SN J6801A-02

S E R V I C E N O T E

J6801A

All J6801A's were assembled with PCB's lacking 2 parts critical to proper operation.

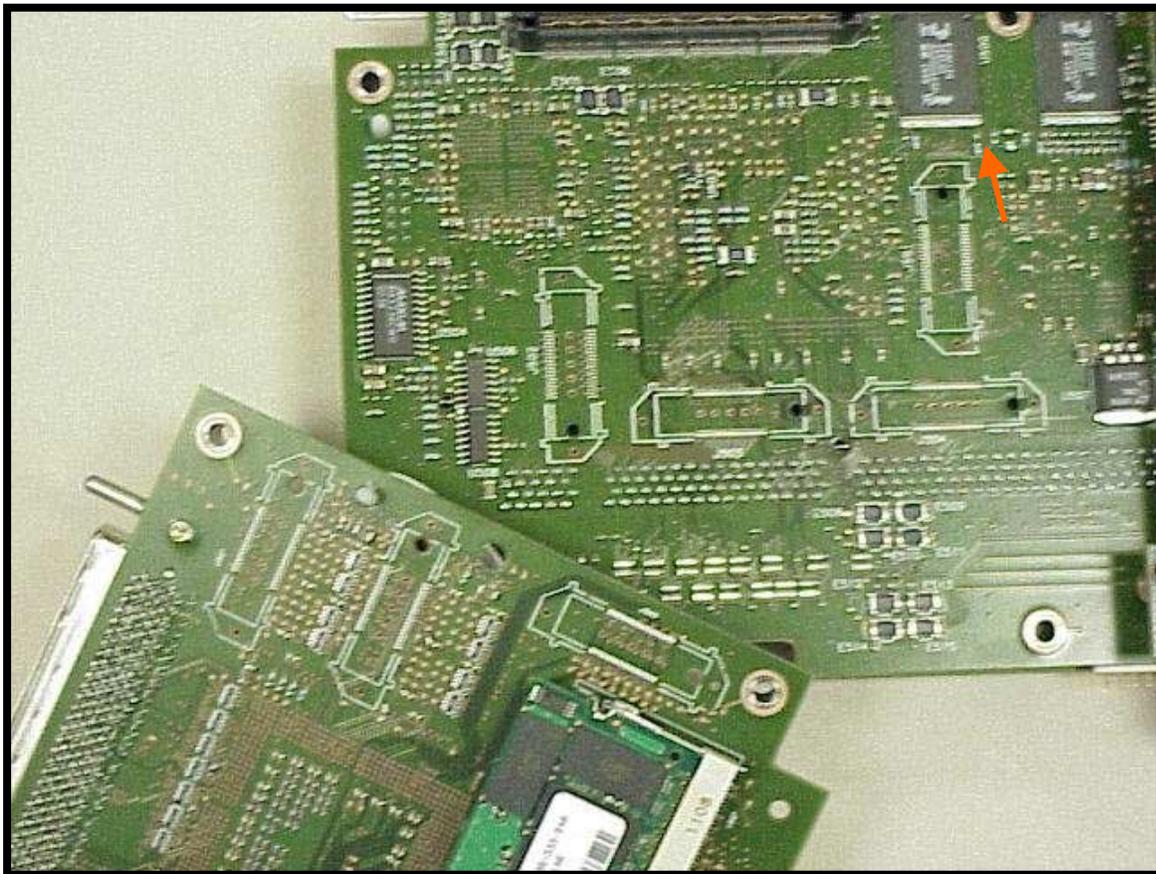
Next, turn the board stack over and remove the oscillator located at U5. Replace it with Part Number 1813-1243. See picture on next page. Re-assemble the unit, test and return to customer.

Must be 80.00
MHz not 88

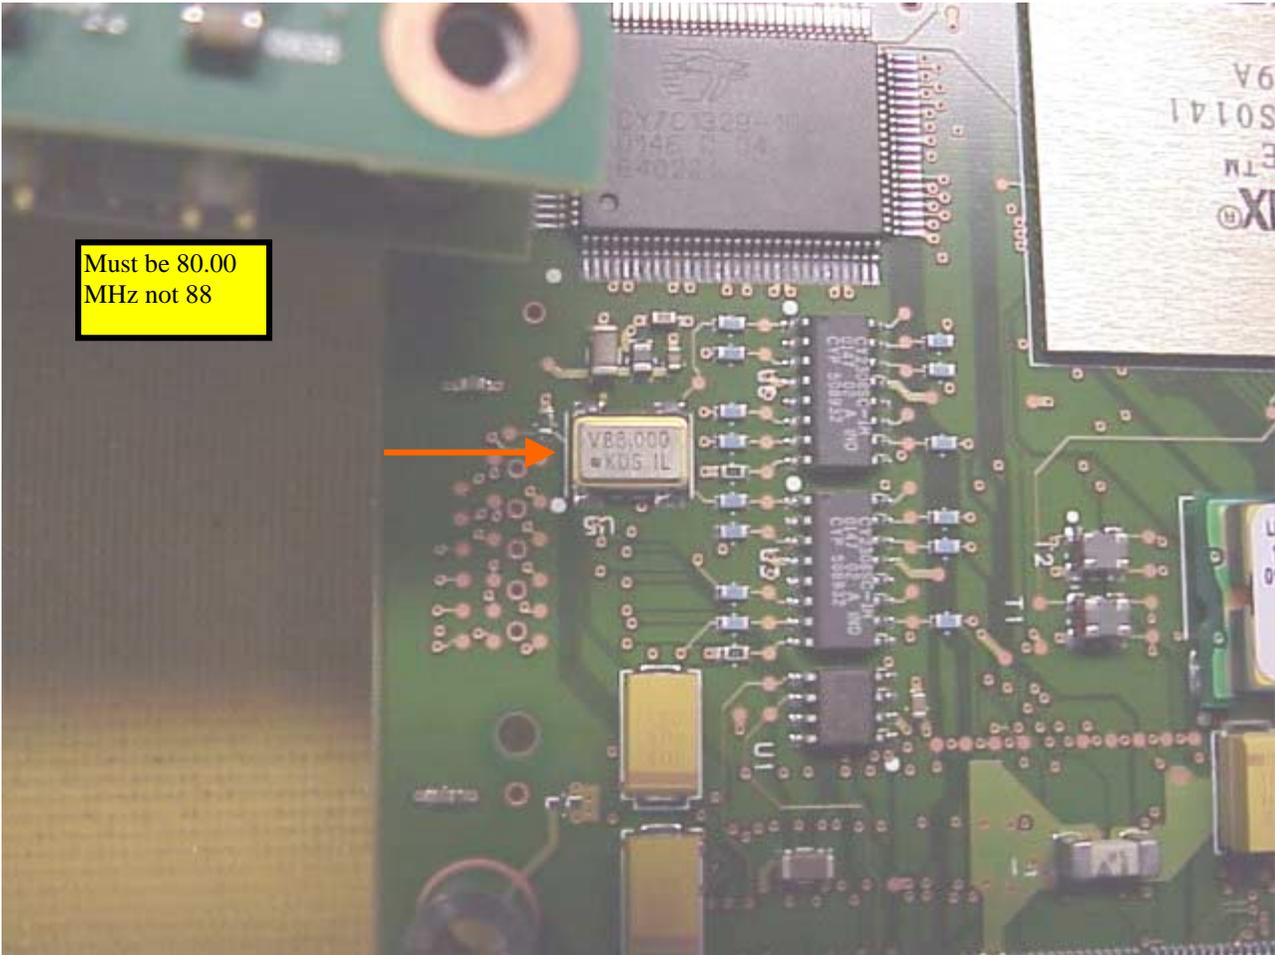
When the next release of Software for the J6801A, currently scheduled for August, is downloaded into units, the download will fail to properly install itself. Also, proper operation cannot be assured as the 88 MHz. Clock that is loaded on the boards is not the correct frequency.

Add resistor R526 (0699-3874) to the location on the PCB signified by the red arrow. It should be placed on the pads adjacent to the two holes in the PCB.
